Planning Commission Staff Report

SUBJECT: DR18-29 MERCY MEDICAL COMMONS II

Approve the Findings of Fact and approve DR18-29, Mercy Medical Commons II: Site plan, landscaping, grading and drainage, elevations, floor plans, lighting, colors and materials for a 62,431 square foot medical office building on approximately 5.9 acres, generally located at the southwest corner of Mercy Road and Rome Street, and zoned General Office (GO) with a Planned Area Development (PAD) overlay.

SITE PLAN

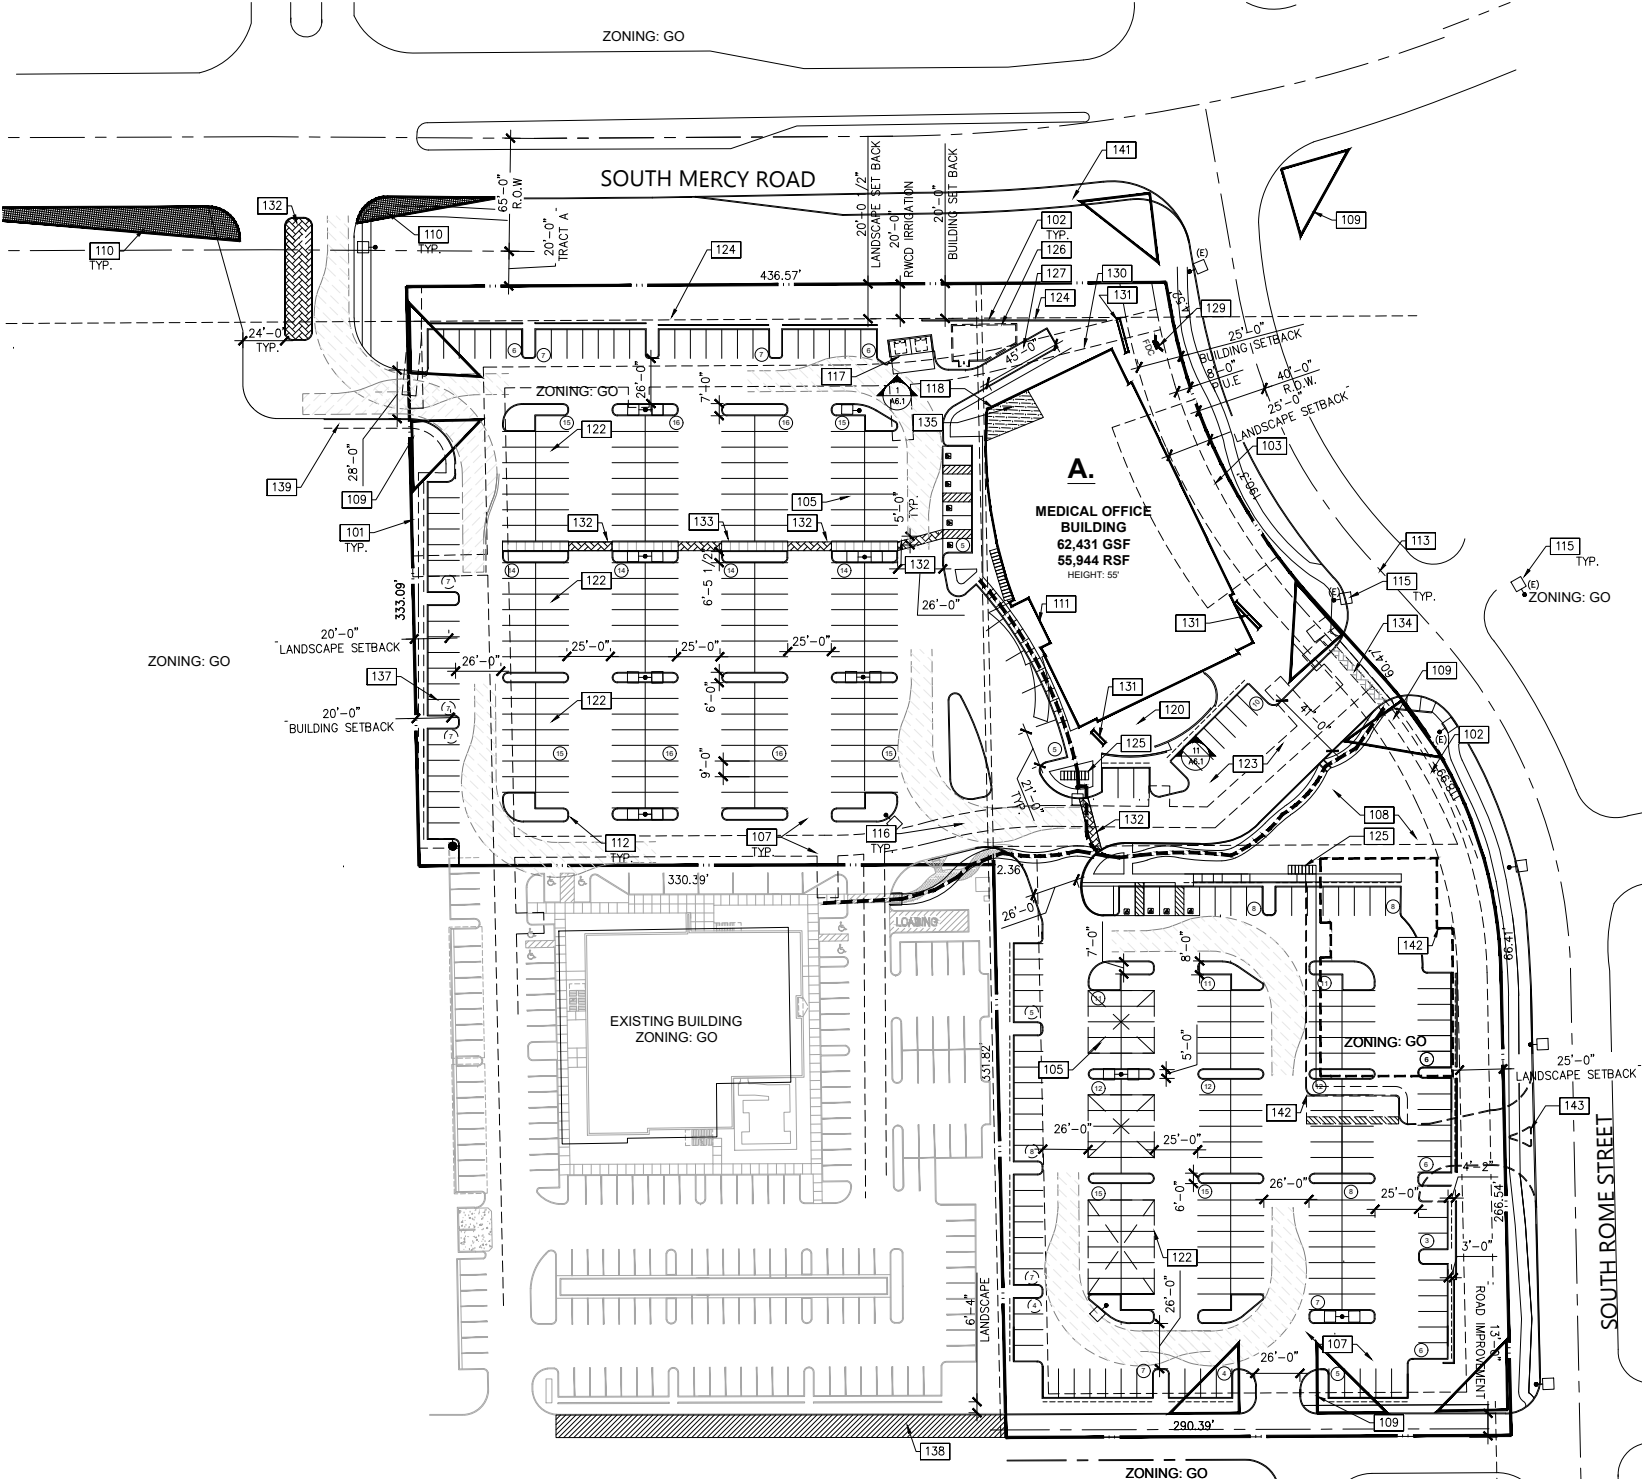
- Commissioners suggested that a tree lined pedestrian sidewalk be provided through the northern parking lot to provide safe pedestrian connectivity to the building and alleviate the effects of summer heat.

- Commissioners questioned whether or not the covered parking spaces depicted on the site in the southern parking area were assigned/reserved spaces or whether or not customers could utilize them. It was suggested if they aren't reserved that additional covered parking be provided in the northern parking lot.

- Commissioners discussed the location, design and screening of the proposed trash enclosure and loading space, which both face Mercy Road. It was suggested that both the trash enclosure and loading space be properly designed and adequately screened as they are highly visible from the public right of way.

- All plans have been updated to include a sidewalk with stamped asphalt in the middle of the northern parking lot that is shaded by Desert Museum Palo Verde Trees.

- Covered parking stalls will now be provided in both the northern and southern parking areas. It has not been specifically determined how those spaces will work, however, employees may be allowed to use the covered spaces on the south lot as an incentive.

- The proposed trash enclosure will be screened to include double metal gates on the south side and a 6' tall CMU enclosure wall on the three other sides that matches the materials and colors of the adjacent 3' parking lot screen walls. A matching 3' screen wall will be constructed in front of the loading space as well. In addition to the enclosure and screen walls landscaping will be planted in the immediate area to further enhance the visual appearance from public view.
